Projects:\21597\2013 Emergency Project\Monitoring and Work Reports\2020 Annual Report

Subject: DEP File No. SE48-2824 | 2020 Annual Report Review Comments

Figure 2 - Cumulative Sand Contribution

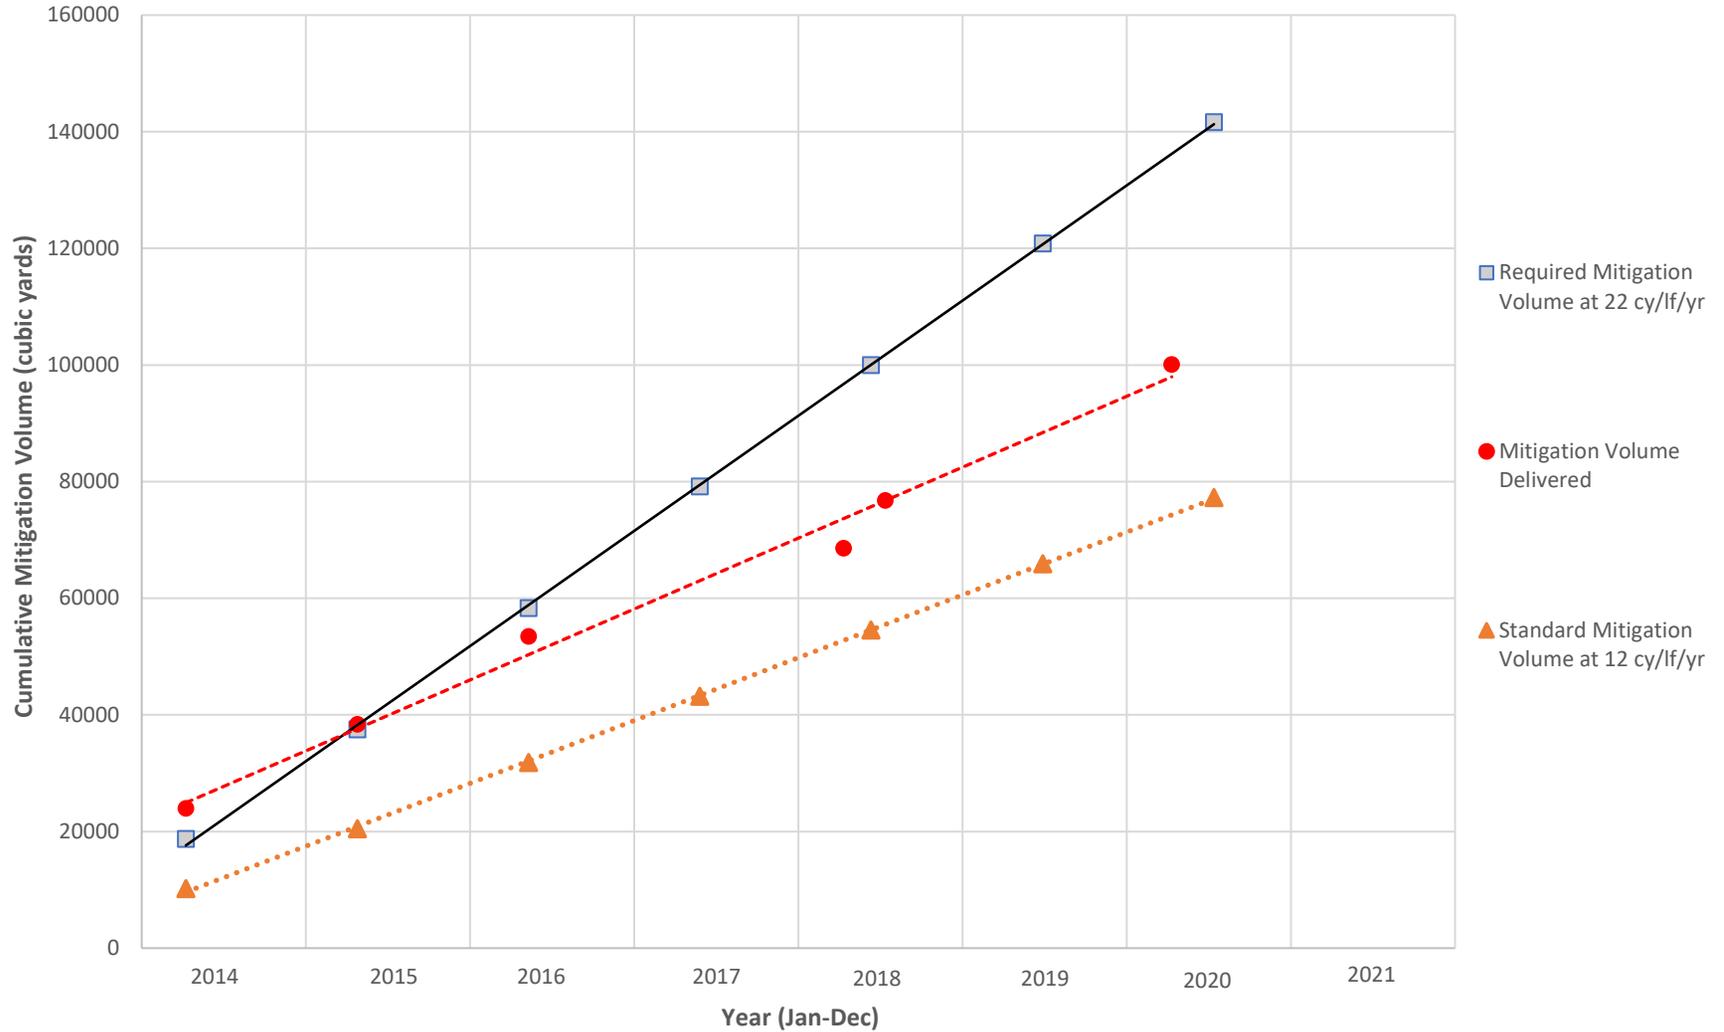
1. ... *Line 13 of Table 1 that there is **26,637 cy of sediment deficient** from the required volume as of 01/15/2021. Similar to last year, the report also indicates on Line 14 of Table 1 that if the applicant were only required to fill the template to 22 CY/LF then would currently be a surplus instead of a deficiency. However, this type of adaptive management has not been approved, and the surplus in the template combined with a deficit in nourishment volume may indicate that the template may not be providing sediment to the beach system during non-storm periods. ...*

- 3. The project site has received the required volume of sand in only one of the sand years since 2015. While there is some fluctuation, the net deficit has been increasing over time and the current deficient volume is 26,636 CY (significantly more than one year's requirement). While the deficit was somewhat reduced from 2018-2019, it has increased even more in 2020. The trend of increasing deficit nourishment volumes is concerning and should be addressed. As the trendline in the graph above shows, continuing this trend will lead to a potential deficit of >50,000 CY by 2025. Reexamining the appropriateness of the required mitigation volume is not part of this review. Assuming the required volume is appropriate, then there is a significant disruption in the supply of sediment to this region.*

9. *In the 2020 Sand Year less than the required amount of sediment was provided to the project area resulting in a current net deficiency of 26,637 cy. This continues a disturbing trend of increasing deficits which may lead to negative impacts, although the current reporting requirements have not shown such an impact. A more direct look at potentially changing volumes in longshore sediment transport may of use in determining downdrift impacts. The annual volume of sediment eroded from a coastal bank can vary greatly along this section of shoreline, therefore there might be some leeway in providing the exact volume each year (at least from a coastal processes point of view, if not the Order of Conditions). However, over the long-term more sediment will need to be provided to average out these years of deficit.*

The volumes delivered to the template are not in dispute, neither is the deficiency from the permit volume new information nor disputed. In terms of deficits, one needs to distinguish between permit volume and natural bluff contribution volume (coastal process perspective). As has been stated many times, the permit volume is 1.83 times the natural pre-construction bluff contribution rate, 22 cy/lf/yr versus 12 cy/lf/yr. As summarized in Table 1 below, the sand delivered to the template annually and cumulatively has exceeded the unprotected bluff contribution volume.

This is also presented graphically in Figure 1, attached.

Please see response to #1 above. The deficits referred to in the comment are relative to the permit volume. The actual volume delivered to template has exceeded the volume that would have been contributed off the unprotected bluff.

- (a) The deficit cited by Mr. Berman is the deficit from the permit volume, while there has been a surplus contributed off the template as compared to the unprotected pre-construction bluff contribution rate (i.e., the coastal process point of view). See Table 1 above and Figure 1 attached. As Mr. Berman writes, “... *there might be some leeway in providing the exact volume each year (at least from a coastal processes point of view, if not the Order of Conditions).*”
